ECONOMISER ASSEMBLY

DRG NO : EC-01-GA-001
DRG REV : B
SCALE : NTS SIZE : A3
SAMPLE (SYNTHETIC) DRAWING

BOM CHECK SUMMARY

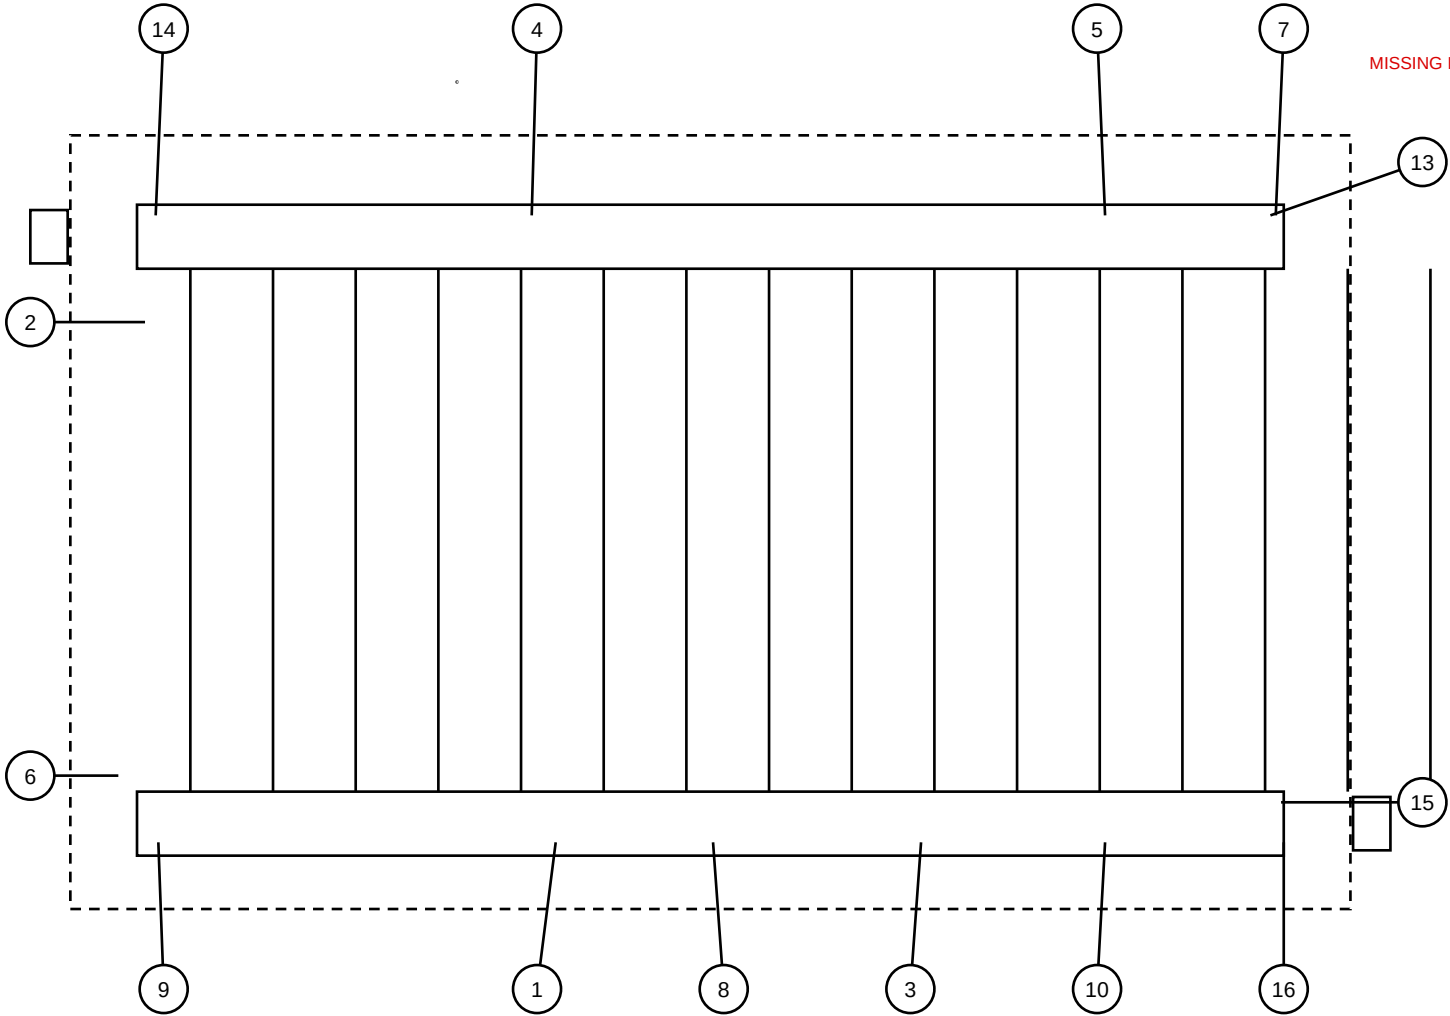
- NOTES:**
- 1. ALL DIMENSIONS ARE IN MM.
 - 2. ALL WELDING AS PER IBR / ASME SEC I.
 - 3. INSULATE WITH 100 THK MINERAL WOOL AND **CLAD** WITH 0.6 THK ALUMINIUM SHEET. <- BOM LACKS: Cladding

[RED] Item 12 'STUD BOLT M20 X 90 WITH 2 NUTS' (qty 16) is on the drawing but has no BOM line
[ORANGE] Item 6: specification mismatch - dimension: drawing ['200'] vs BOM ['250']
[YELLOW] BOM row 23 'Outlet header 219.1 OD x 8 thk' repeats item 2 (already covered by BOM row 7)
[BLUE] Suggestion (Cladding): the drawing notes imply it, but no matching line was found in the BOM
